EAGLE COUNTY ENGINEERING

FILE: Eagle County File No. VIS-4398

RE: Berlaimont Estates Variance to Improvement Standards Engineering Review

rd-02.pdf

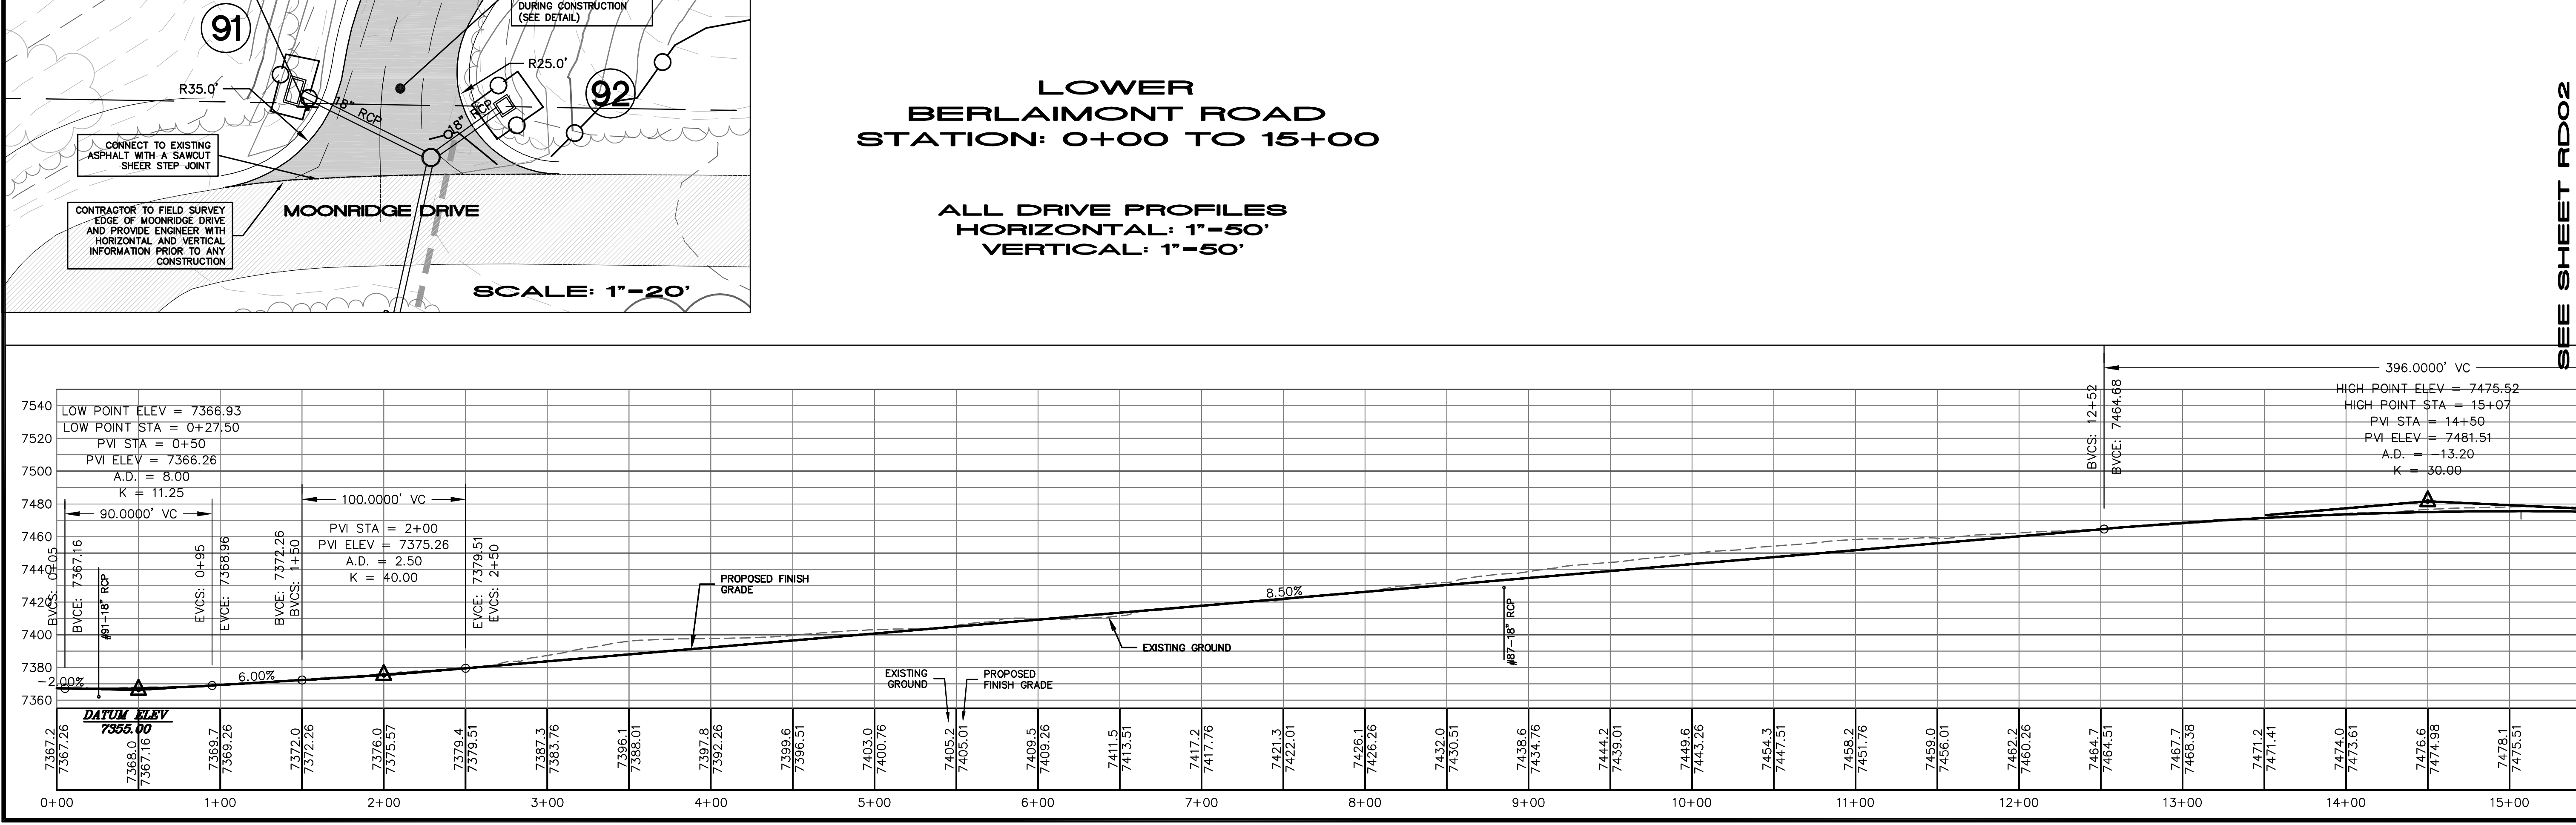
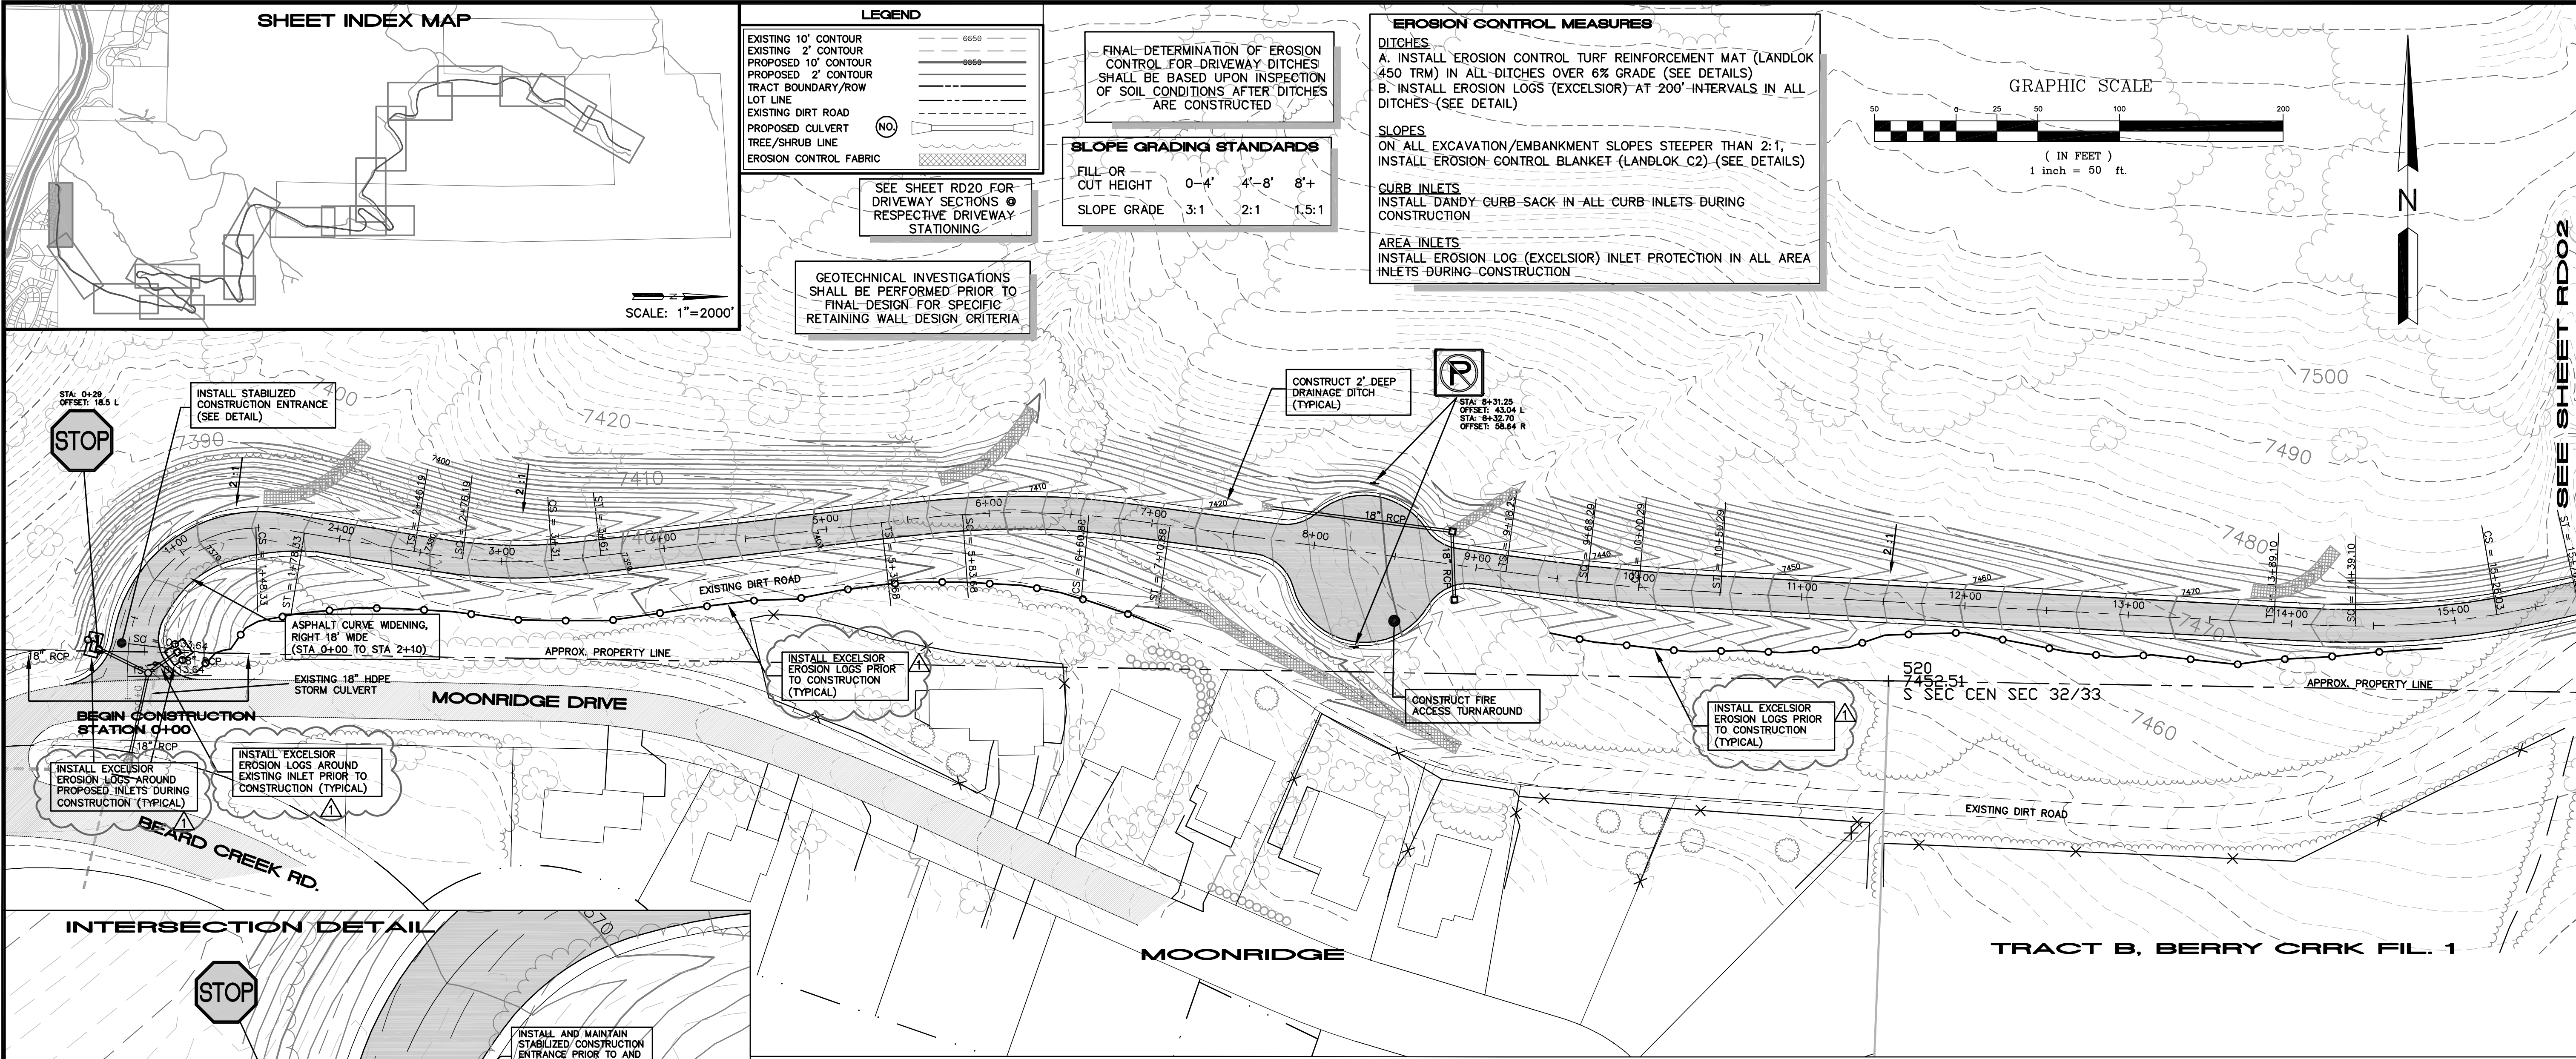
1. Please show the property line for property owned by Berry Creek Metro District in relation to the proposed improvements.
2. Eagle County Engineering will rely on the Eagle River Fire Protection District for guidance on the acceptability of the proposed Emergency Vehicle Turn-around variance request and their ability to provide service to the development.
3. This application only includes the access roadway up to a point approximately 475-ft from the property line with USFS. This variance would not apply to the road extension to the home sites. We would encourage the applicant to include the complete development road design to avoid the need for an additional Variance application.
4. Please confirm that the roadway design uses 6% maximum superelevation and AASHTO standard superelevation transitions.

The attached sheets show the property that is owned by Berry Creek Metro and the property line based on the plat for Berry Creek Ranch (also attached). No new improvements are proposed on Berry Creek Metro land.

Also, the roadway design uses 6% maximum superelevation and exceeds AASHTO standard superelevation transitions.
